**Re: Response to EPA Analysis of the *Final Habitat Mitigation and Monitoring Plan*, dated September 12, 2017, EPA Comments October 5, 2017 (Revised November 30, 2017)
Rosemont Copper Project, Clean Water Act Section 404 Permit, CoE File No.: 2008-00816-MB**

**RESPONSE TO ENVIRONMENTAL
PROTECTION AGENCY (2017)**

**"The Mitigation Proposed by Rosemont Mine
Will Not Offset Impacts to Waters of the U.S.
below the Level of Significant Degradation"**

Project Number: 1049.117
January 24, 2018

Figure 1. Rendering of Existing Sonoita Creek from Highway 82

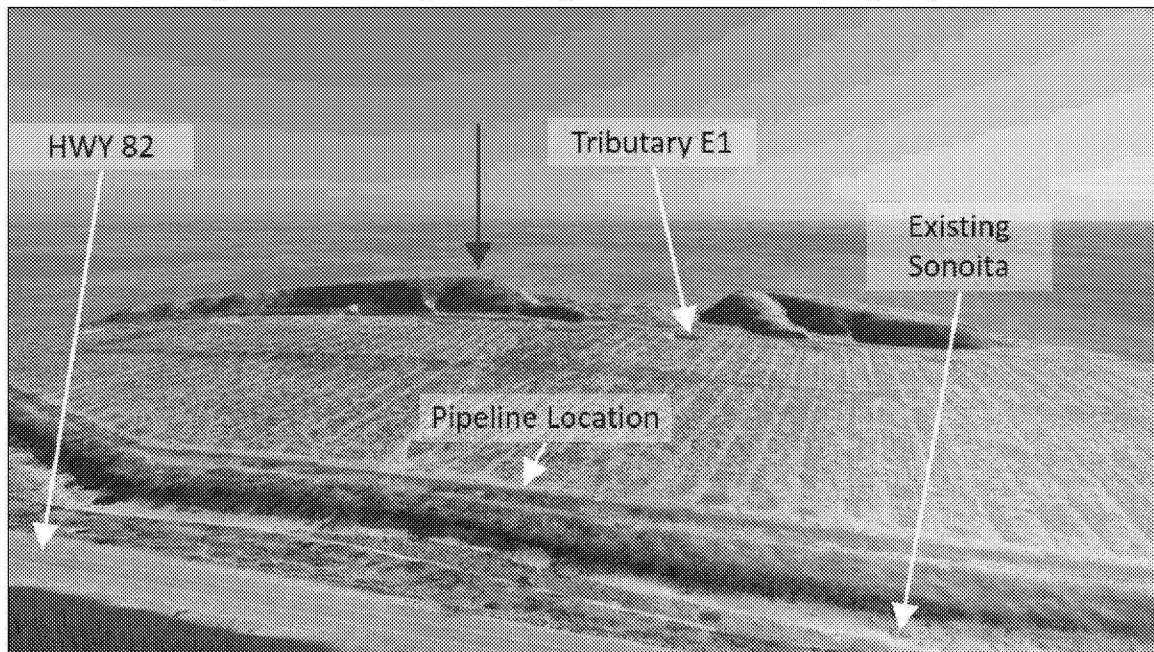
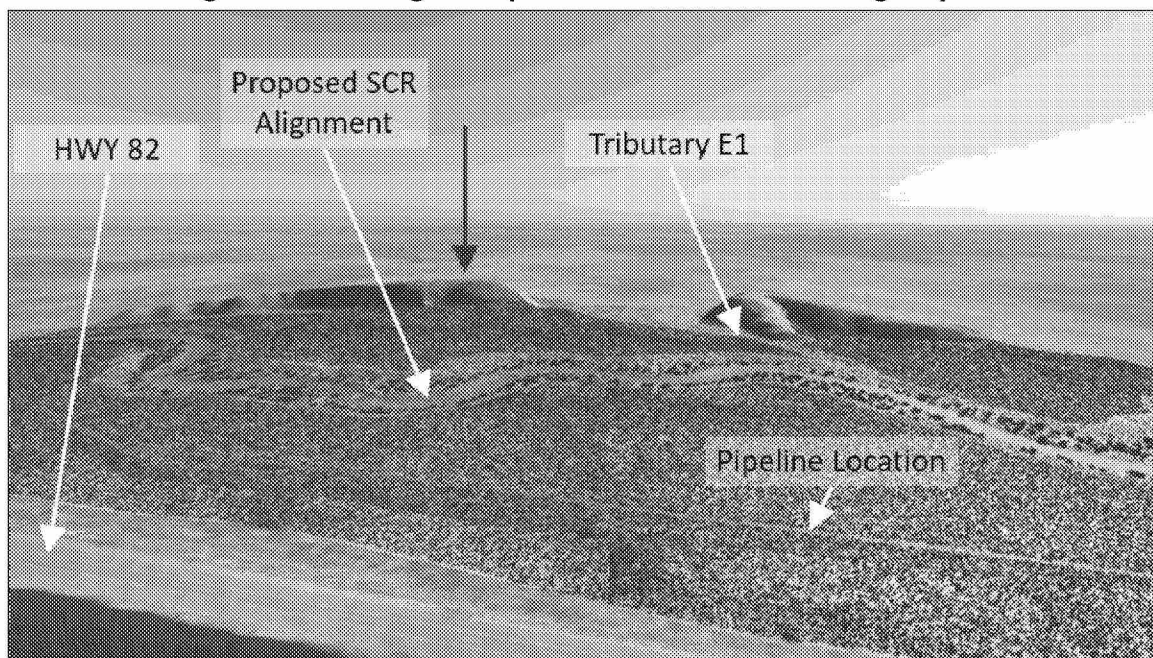
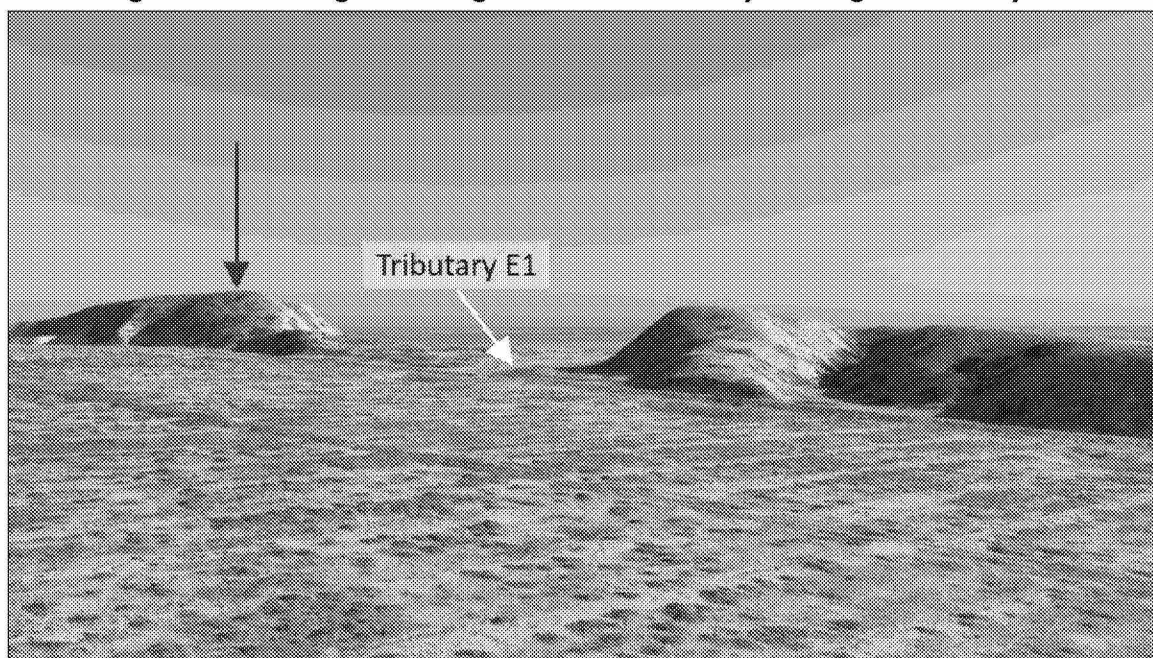
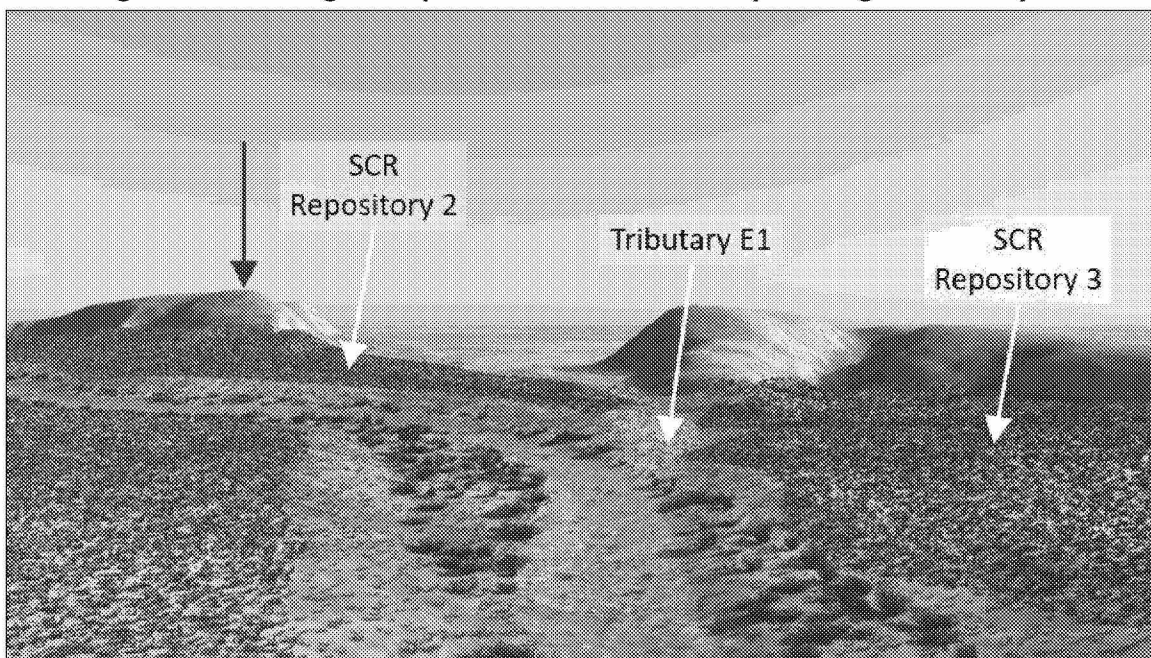
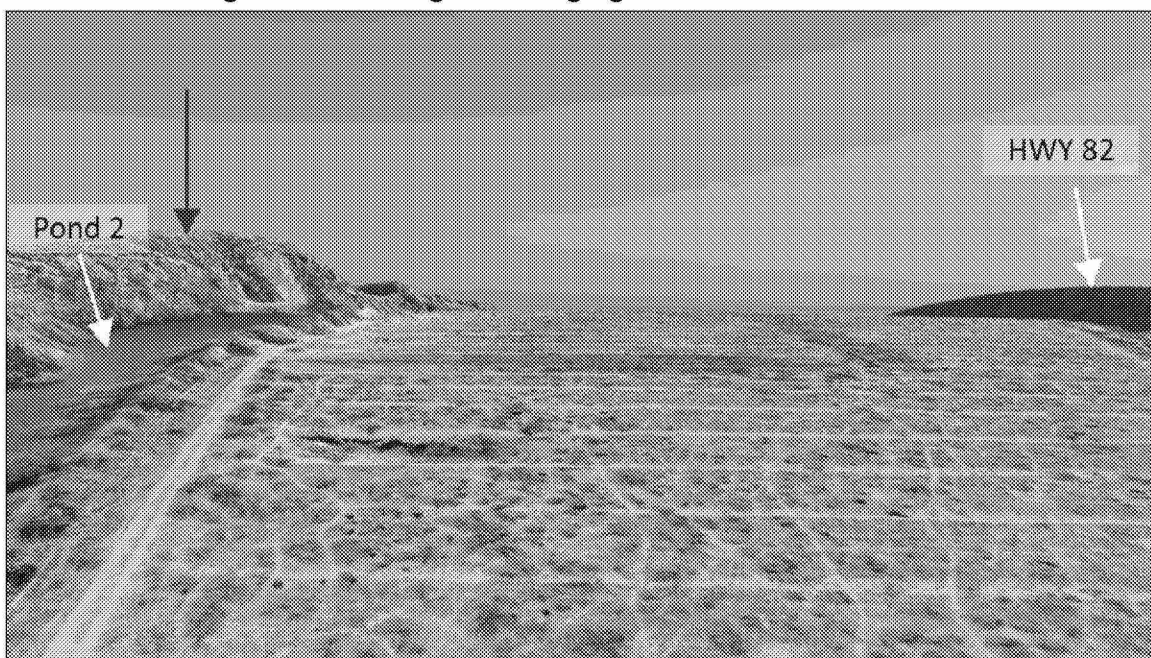
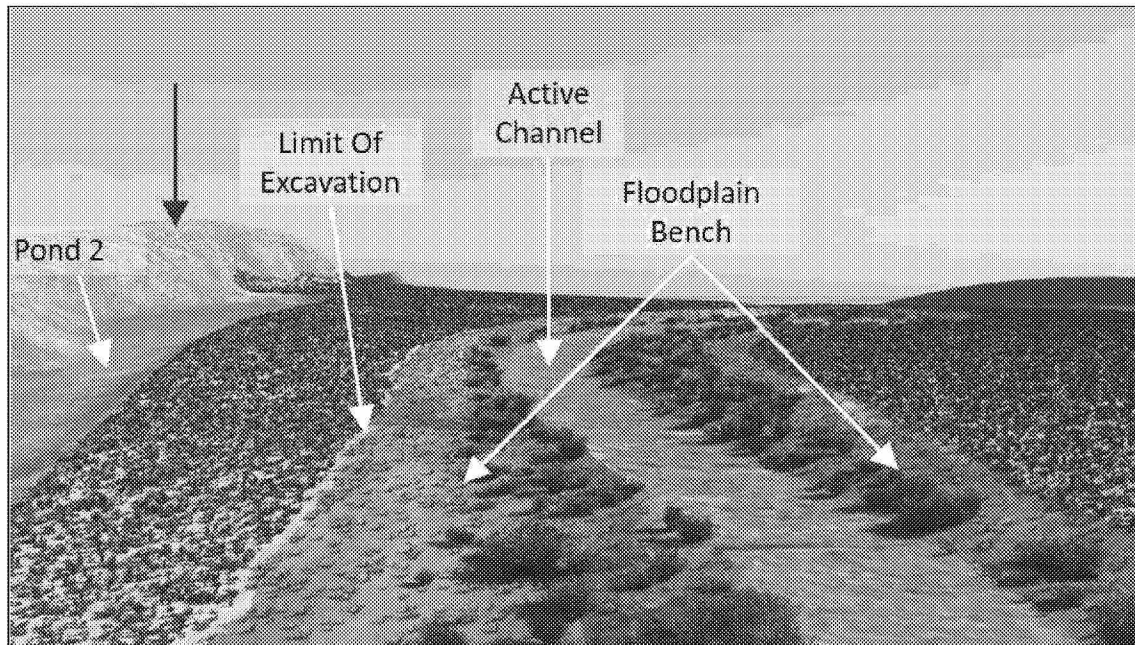
The Sonoita Creek restoration project incorporates comprehensive manipulation to the Sonoita Creek stream channel that will repair historic straightening and ongoing incision, reconnect the channel to the floodplain and relocate the channel relative to its valley and away from confinement by infrastructure (**Figures 1 through 6**).

The proposed channel construction project restores the stream channel to its former location, resulting in a gain in aquatic resource area. That is, the aquatic resource (the stream channel) is being reestablished in the area it formerly occupied. Further discussion of the historic evidence of channelization of Sonoita Creek is provided in **Section 2.3**.

Figure 7. Sinuosity Measurements on Big Casa Blanca Canyon**Figure 8. Existing Sonoita Creek Sinuosity Measurements**

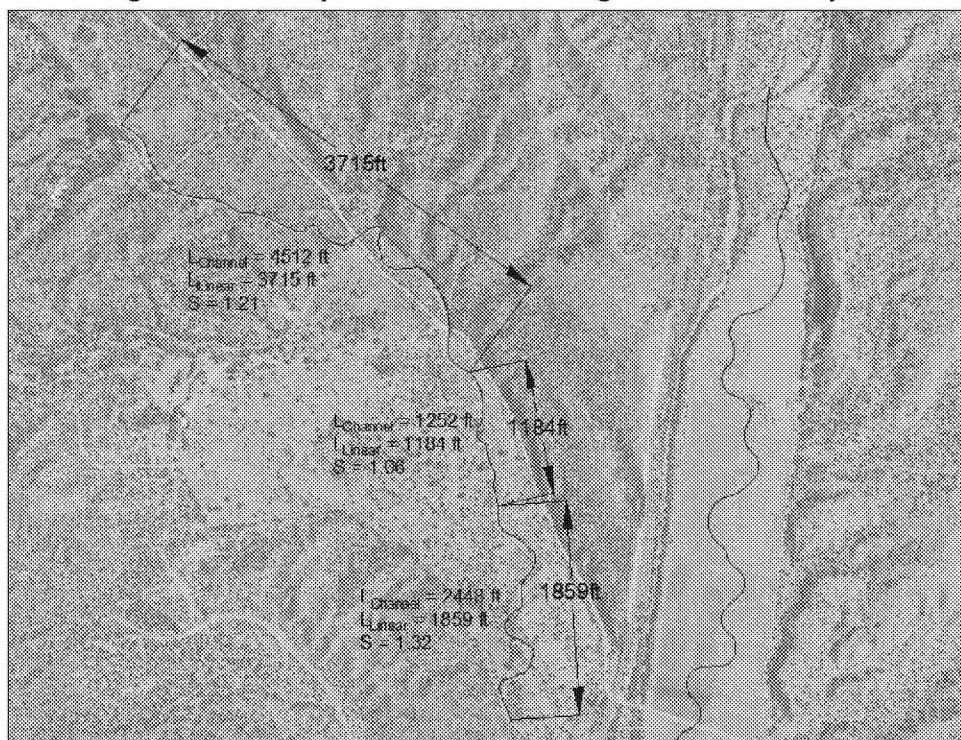
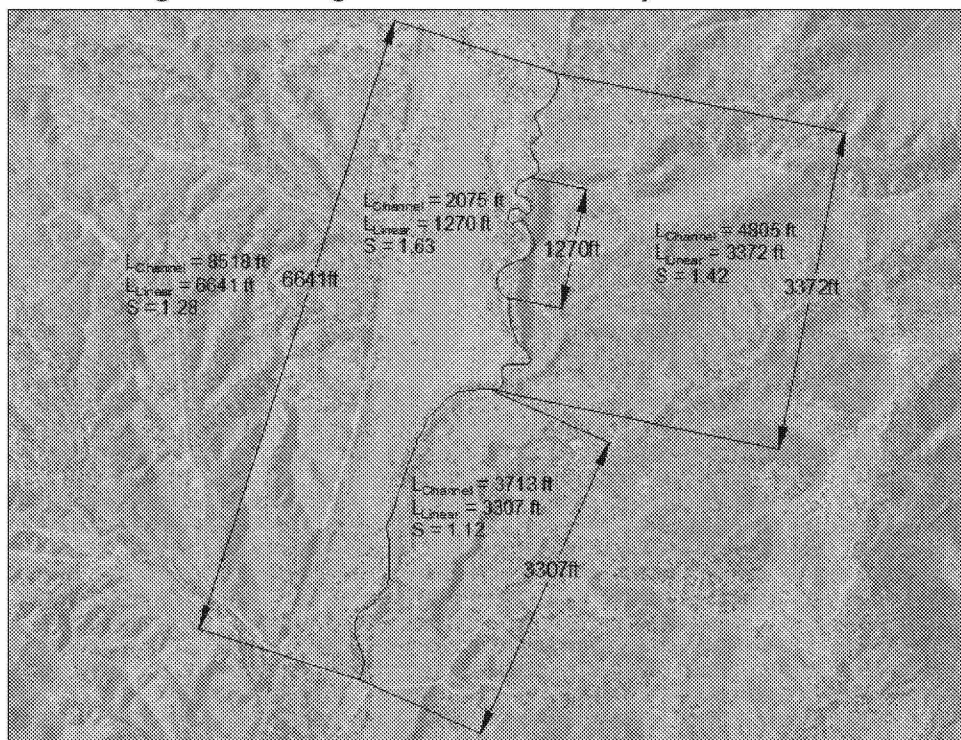
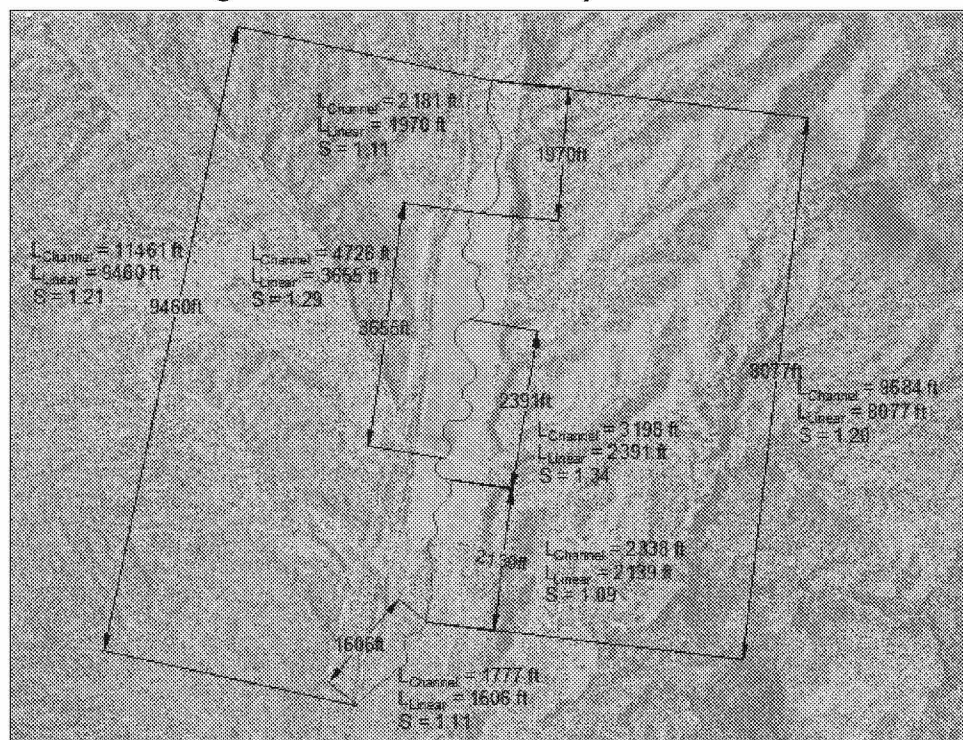
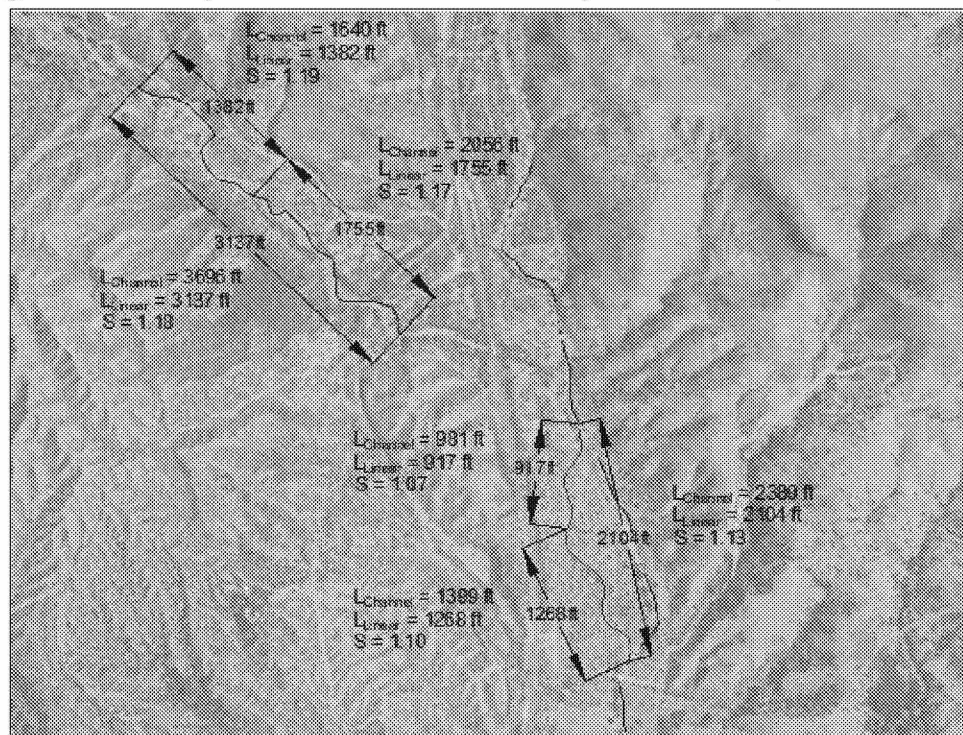
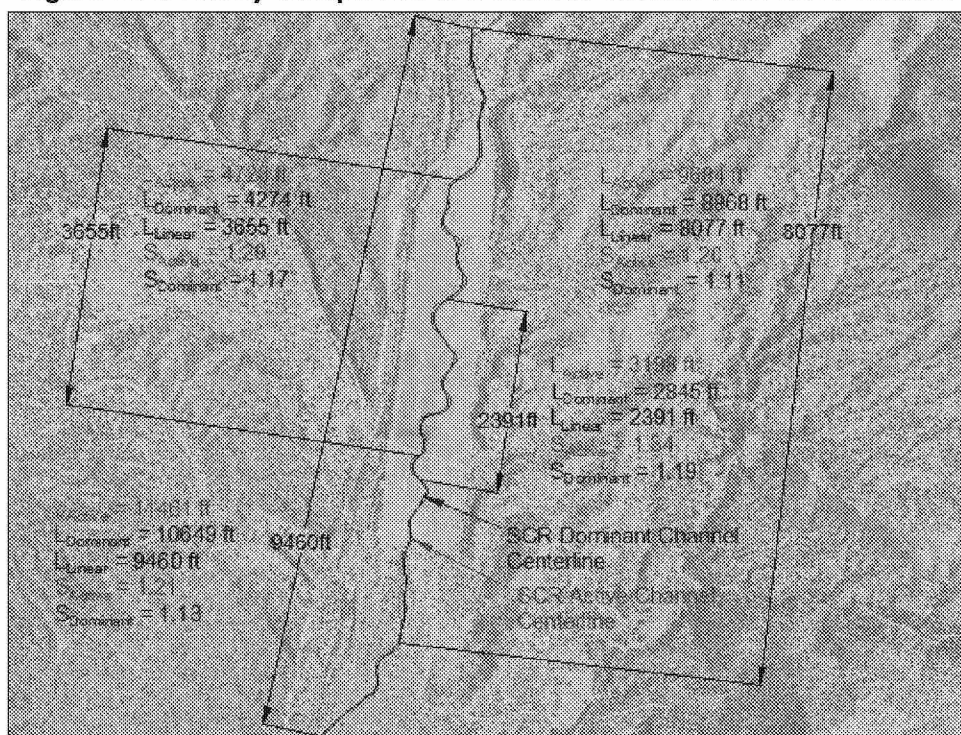
More sinuosity measurements of the existing and proposed configurations of Sonoita Creek are presented for this response than in the HMMP, and they support the design sinuosity as proposed. The least altered, and most functional, dynamic reaches of Sonoita Creek and its tributaries, are not well represented by any single, uniform value of sinuosity, such as the 1.13 value presented by the EPA. Measured sinuosity of the proposed channels is within the measured range of sinuosity for the least-altered reaches of Sonoita Creek, Adobe Canyon, and Big Casa Blanca Canyon (**Table 1; Figures 7 through 10**). Average measured sinuosity of the proposed SCR Channel is 1.21, but the sinuosity measurements range from 1.09 to 1.34 (**Figure 9**), which is within the range of observed sinuosity for existing, functional and dynamic reaches of Sonoita Creek and its tributaries.

The proposed channel planforms are designed with multiple considerations rather than a single measure of sinuosity, and are supported by scientific considerations. The variable sinuosity proposed in the HMMP is better supported by onsite references than a uniform sinuosity value of 1.13 as suggested by the EPA. Furthermore, the dominant sinuosity measured from the inundated surface is 1.13 for the overall SCR Channel, which is equivalent to the sinuosity proposed by EPA, and was not maximized to gain additional mitigation credit.

In response, we note that the sinuosity measured at Adobe Canyon is slightly higher than the proposed sinuosity of the RX Channel (**Figure 10**). EPA's sinuosity analysis included portions of Walnut Gulch between Flume 6 and Flume 2. However, it is inappropriate to include these portions of Walnut Gulch as reference reaches, as they are physically constrained and confined by local geology/topography and

Figure 13. Walnut Gulch at Flume 6 and Downstream

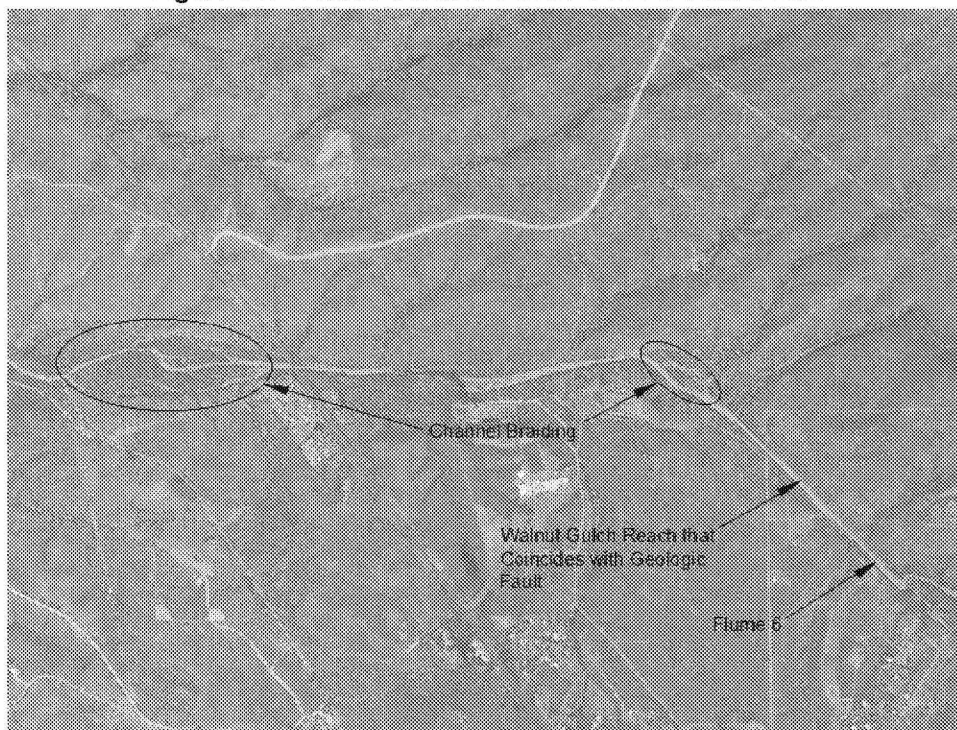
The EPA (2017) states that the HMMP (Exhibit 1) depicts Walnut Gulch from Flume 7 to Flume 1 and further states that Walnut Gulch does not exhibit any braiding patterns between Flume 6 and Flume 2, which demonstrates that Sonoita Creek will likely not exhibit any braiding patterns. The EPA also notes that the reach from Flume 7 to Flume 1 has significantly greater watershed area, tributary inputs, and channel dimensions than the upstream reach between Flume 2 and Flume 6.

The HMMP (Exhibit 1) depicts Walnut Gulch between Flume 2 and Flume 1 as well as downstream of Flume 1, and depicts a tributary to Walnut Gulch at Flume 7. The majority of channel braiding occurs along this reach of Walnut Gulch; this is not the same reach for which hydrologic analyses were conducted and results compared with recurrence intervals and peak flows from the SCR mitigation project. As described in more detail elsewhere, the reach near Flume 6 was identified as most like the SCR design watershed for hydrologic analysis, with its similar watershed area and elevation. However, the reach near Flume 6 at Walnut Gulch has important physical differences from the SCR mitigation project site. Specifically, Walnut Gulch near Flume 6 flows through a narrower valley with more physical constraints that limit channel migration and sinuosity more than the unconstrained physical conditions at Sonoita Creek. The straight reach of channel downstream of Flume 6 is coincident with a geological fault line and is confined by geologic controls, and therefore should not be used as a reference reach for sinuosity to apply to Sonoita Creek. Nevertheless, there is some braiding between Flume 2 and Flume 6 (**Figure 13**).

The occurrence of braiding along Walnut Gulch is more frequent where there is sufficient width of valley floor to accommodate multiple channels. This occurs to some degree downstream of Flume 6, but more significantly downstream of Flume 2, where relatively less confined reaches of Walnut Gulch are more physically similar to the conditions at Sonoita Creek (despite having a larger watershed area) than the reach near Flume 6. When analyzing channel form, the physical/geomorphological conditions in the reach from Flume 2 downstream to Flume 1 better represent Sonoita Creek than upstream at Flume 6, and are thus more representative of the channel form that is expected for the Sonoita Creek project area.

Figure 15. Sonoita Creek Constrained Between Highway 82 and Gas Pipeline

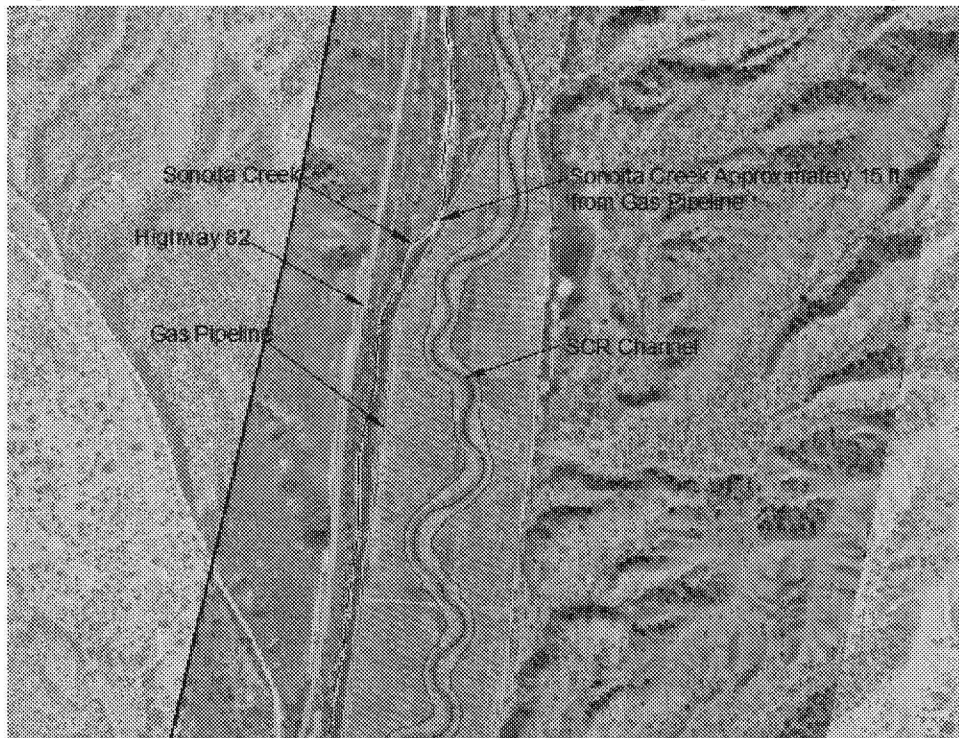
Finally, the EPA suggests that existing Sonoita Creek at SCR could be rehabilitated by excavating portions of the floodplain along its eastern bank.

This approach is not feasible at SCR because the gas pipeline is parallel to and in close proximity to the current eastern channel bank, in one case as close as about 15 feet (**Figure 15**). Furthermore, rehabilitating only the eastern bank would still leave in place the existing west bank, constrained by the highway and significantly manipulated and degraded by concrete channel walls and gabion baskets. The majority of the artificial armoring, which precludes channel migration or development as well as access to a functional floodplain, is located at the existing west bank at SCR.

Regarding excavation of portions of the floodplain along its eastern bank, for the majority of the existing Sonoita Creek reach located at the SCR Ranch, we note the following:

- There simply is not adequate space to rehabilitate the eastern bank to provide significant ecological benefit;
- The degraded and manipulated west bank will continue to limit functions including: flow access to floodplain, energy dissipation, development of an ecologically functional riparian zone with diverse and/or robust vegetation and wildlife habitat;
